# Technical Service Information

## THM 4L60 (700-R4) NO AND/OR DELAYED REVERSE

Figure 1

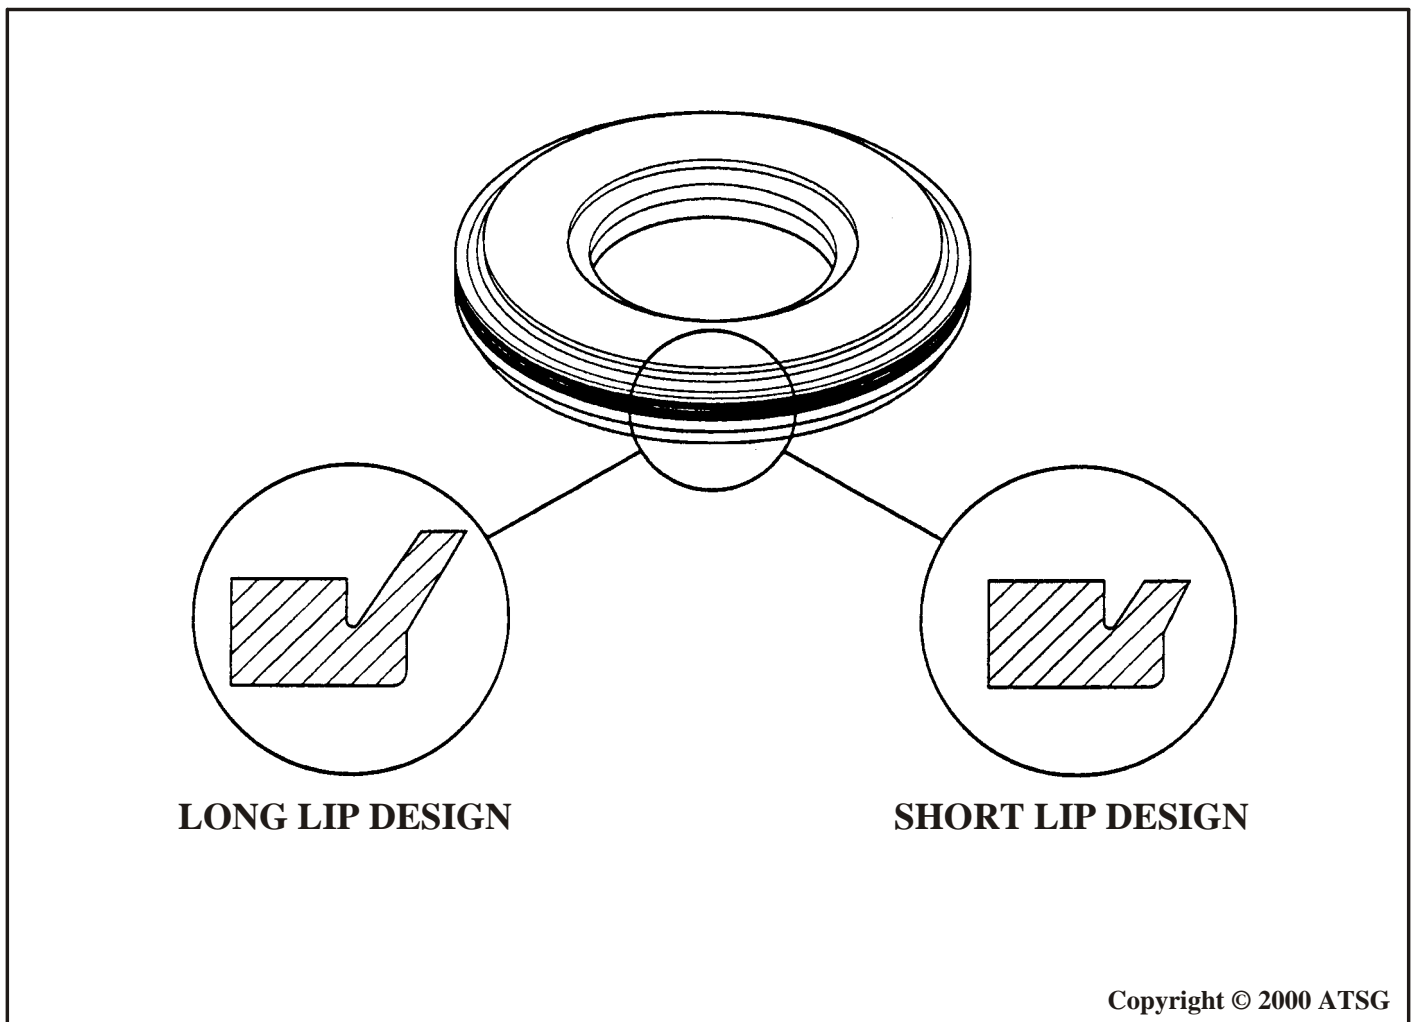
**COMPLAINT:** Some 1989-1991 THM 4L60 (700-R4) transmissions may exhibit a no reverse or delayed reverse condition, especially when the outside temperatures drop near 20° Fahrenheit.

**CAUSE:** The cause may be a "Short Lip" design seal installed on the reverse input clutch piston outer seal (See Figure 1).

**CORRECTION:** Install the "Long Lip" design seal on the reverse input clutch piston outer seal (See Figure 1). NEVER install the short lip design seal, as the manufacturer has now gone back to the long lip design on all models.
